EXHIBIT "A"

REVISED SITE PLAN (12/31/87)
RESIDENTIAL COMMUNITY UNIT PLAN

AUTUMN RIDGE

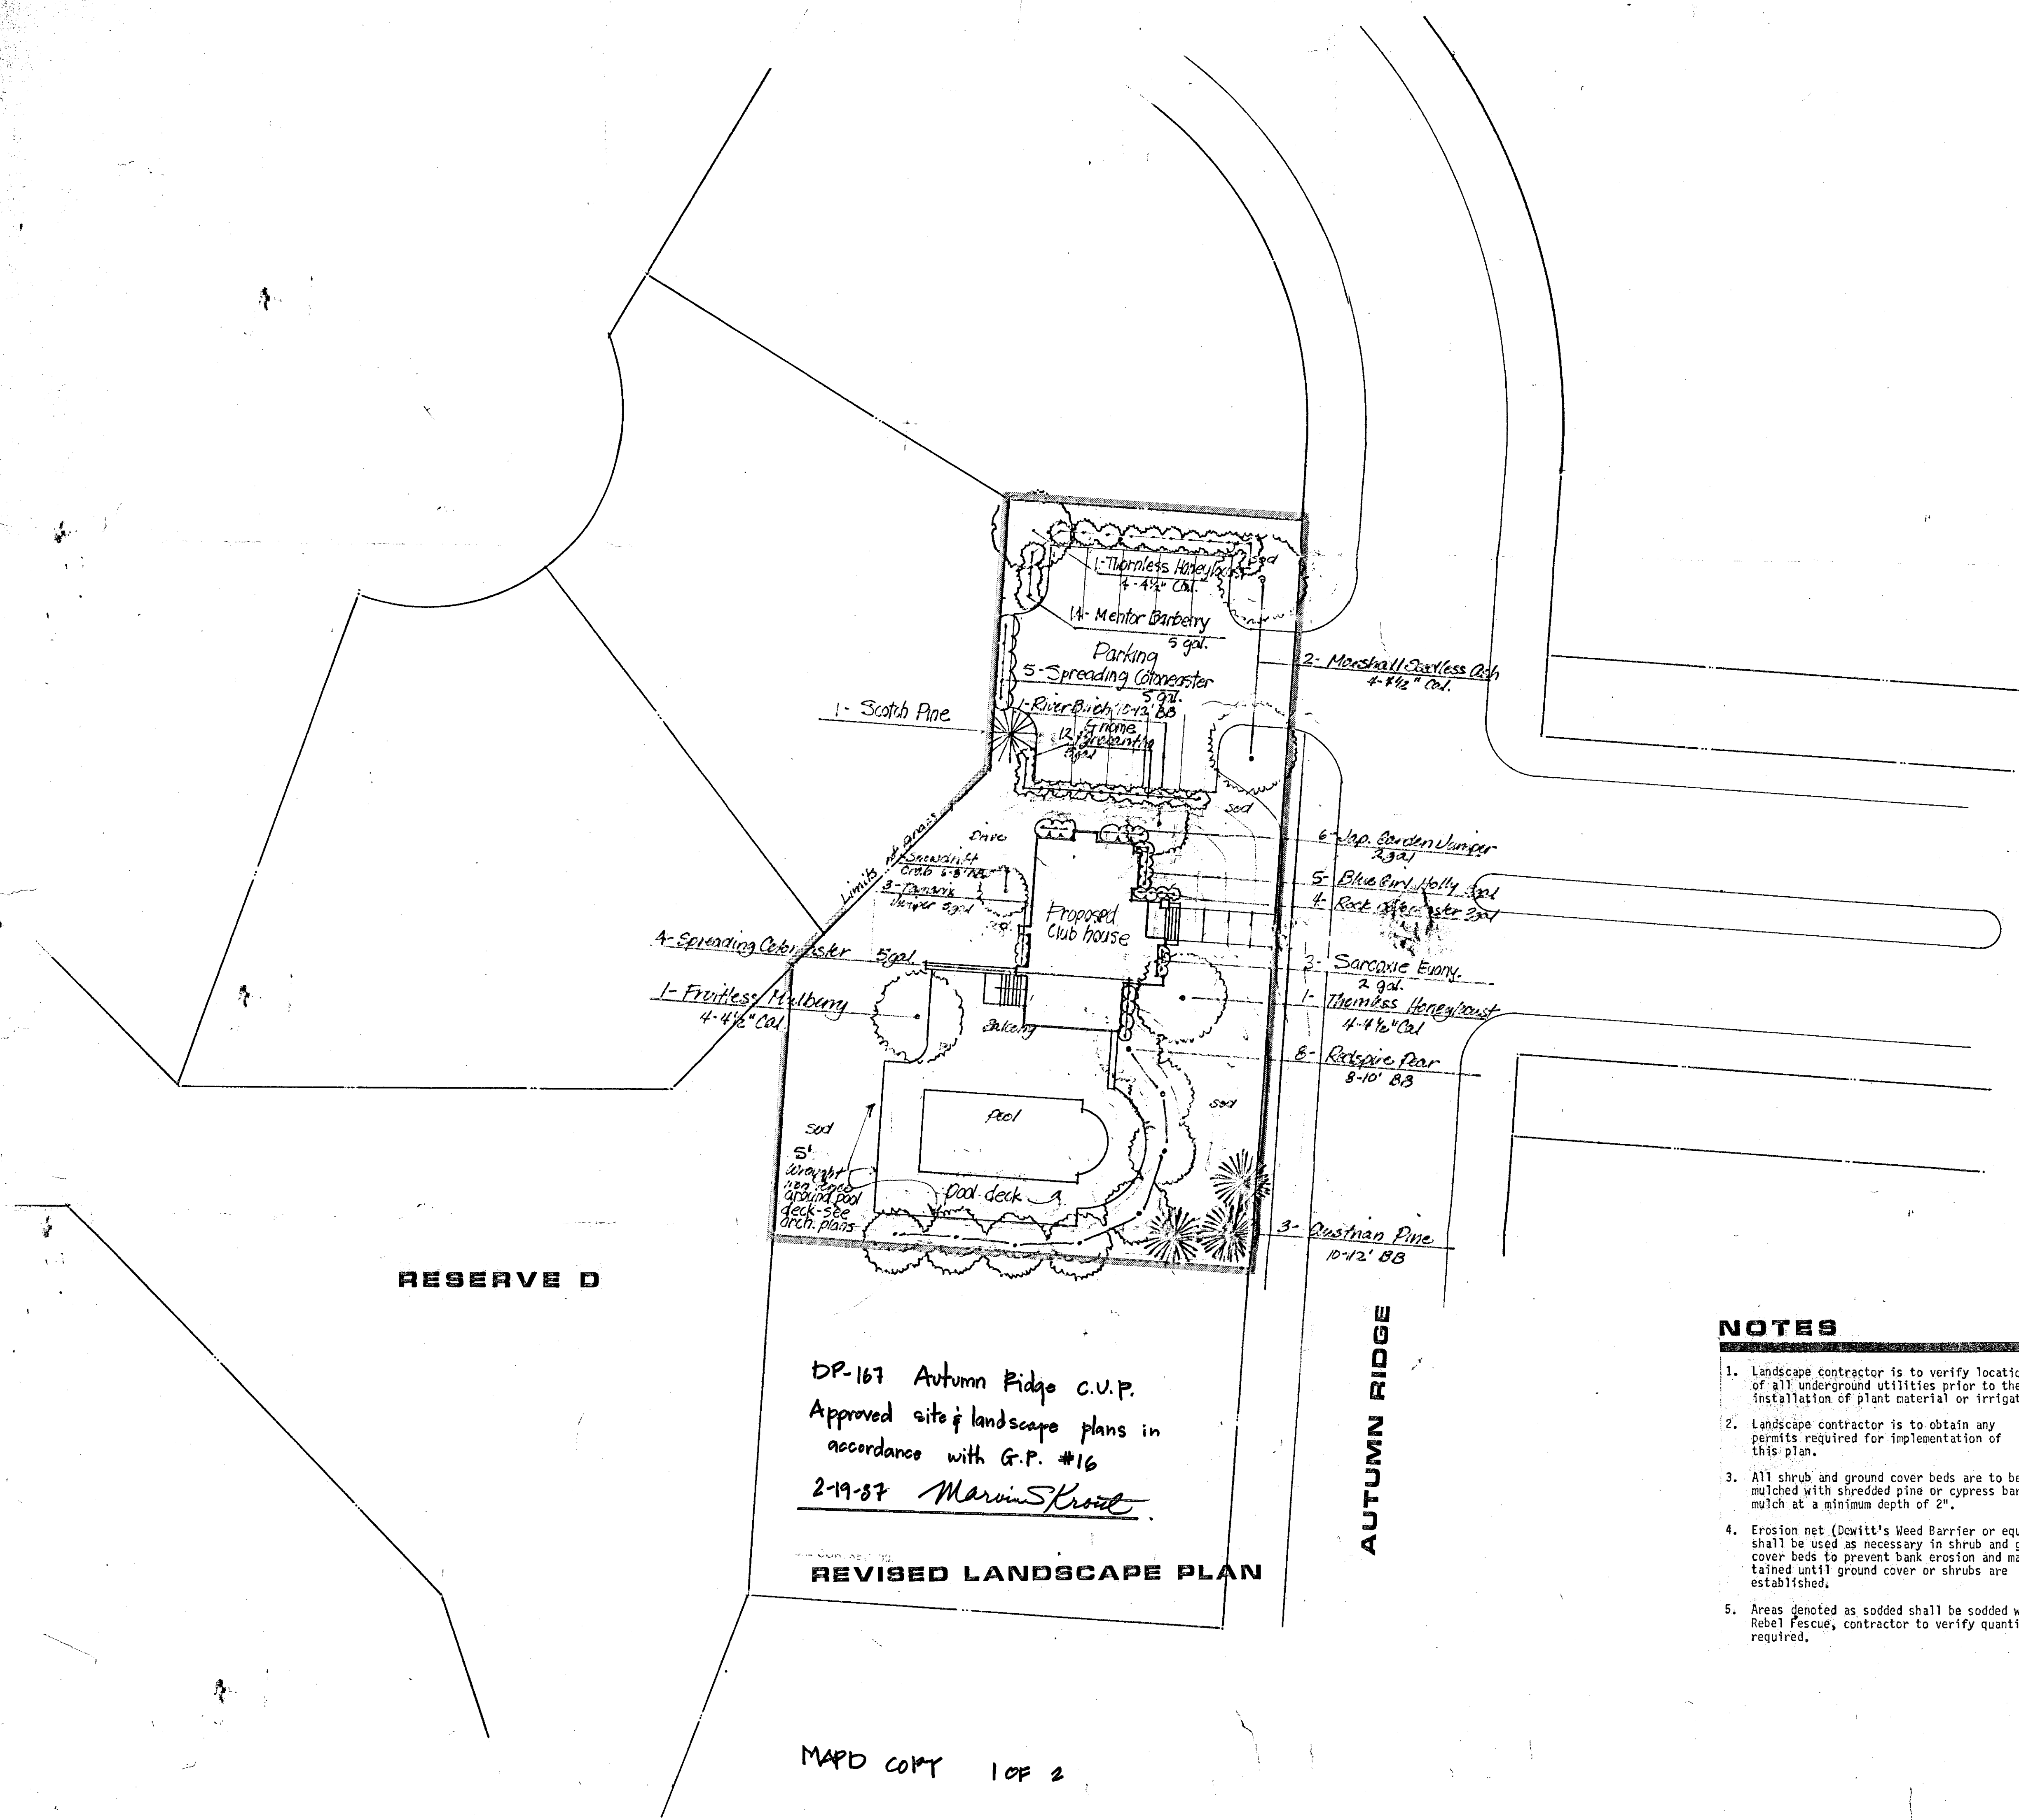
1. THIS PROJECT IS PROPOSED TO CONTAIN 29.90 GROSS ACRES OR ~~29.90~~ ^{33.37} NET ACRES. NET ACRES ARE DETERMINED BY SUBTRACTING STREET R.O.W. FROM THE OVERALL DEVELOPMENT.

3. NET DENSITY CALCULATION: THE OVERALL ILLUSTRATED DENSITY OF THE SITE WOULD BE ~~3.37~~ ^{3.86} DU/ACRE. THE ALLOWED NET DENSITY WOULD BE ~~3.37~~ ^{3.86} DU/ACRE.

GROSS ACRES - 27.23
NET ACRES - ~~21.04~~ 20.75
NUMBER OF DWELLING UNITS ILLUSTRATED - ~~69~~ 70
NUMBER OF DWELLING UNITS ALLOWED - 80
NET DENSITY ILLUSTRATED - ~~2.22~~ DU/ACRE 3.37
NET DENSITY ALLOWED - ~~2.94~~ DU/ACRE 3.86
MAXIMUM BUILDING HEIGHT - 35'
SETBACKS - FRONT - 25'
